# REPORT TO PLANNING COMMISSION

**APPLICATION NAME:** PLUMBERS SUPPLY SITE PLAN

**APPLICANT'S REQUEST:** The applicant is seeking review and approval of a Site Plan for a proposed wholesale plumbing supply store.

**FIGURE 1: DISTANCE BETWEEN RESIDENTIAL AND STRUCTURE (RED) & PAVEMENT (BLUE)**

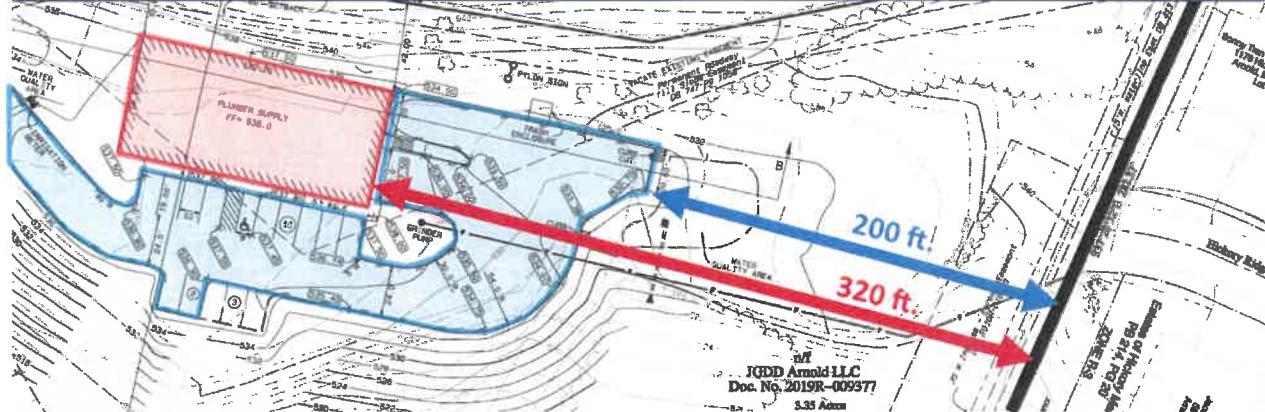
**BUFFER AND LANDSCAPING** As mentioned above, the mitigation of impact on adjacent districts and uses is a priority in any commercial development but especially those that are adjacent to residential. With that in mind, the proposed building is to be located approximately 320 feet away from the property line abutting the common ground of the Estates of Hickory Manor subdivision. The edge of pavement to the same property line is 200 feet. See Figure 1 for sketches of these distances. This is a *significantly larger* buffer than the 15-foot minimum required in situations where structures in commercial districts abut a residential district. These numbers are also larger than the separation distances that were proposed on the rezoning’s preliminary site plan, resulting in an additional 40 feet between the structure and property line and 30 feet from edge of pavement and property line.

FIGURE 3: BUILDING RENDERINGS AND COLORS

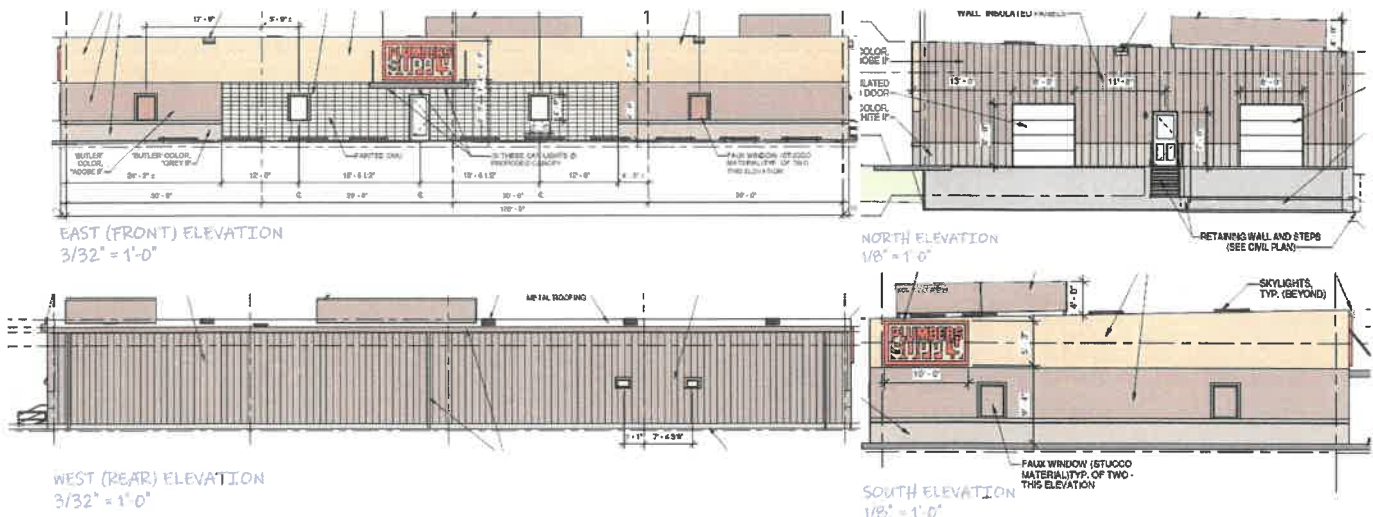
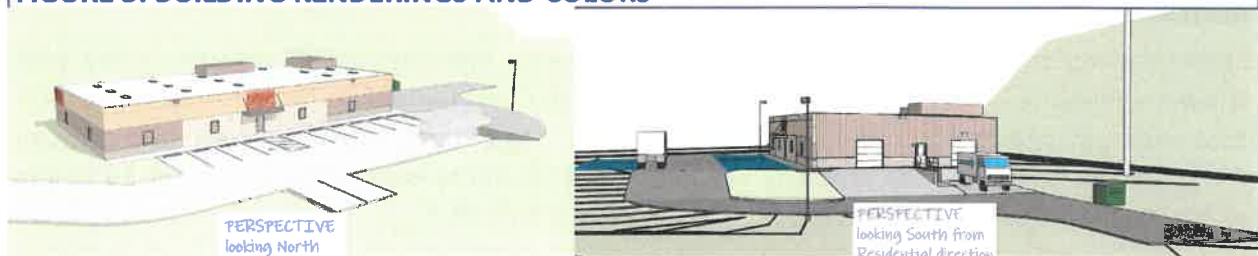
**ARCHITECTURAL RENDERINGS** The applicant has submitted colored architectural renderings from multiple elevations/perspectives. These are shown in Figure 3 and in Exhibit B of this report's Attachments. The building's materials are light and dark tan stucco-finish insulated panels, painted concrete blocks, and painted vertically corrugated metal panels. Staff found the initial renderings to be lacking, and so Staff had requested that the applicant consider additional landscaping, fake windows, columns, or other aesthetic features to break up the building's facades. The applicant considered these requests and implemented faux windows on the south and east elevations (Figure 3).

Minor note: The architectural renderings do not show an enclosure for the dumpster when looking at the site from the second image ("Perspective looking South from Residential Direction") in Figure 3. However, the site plan calls out that there will be a trash enclosure at that location. The trash enclosure shall be a sight-proof fence that matches the material of the primary building.
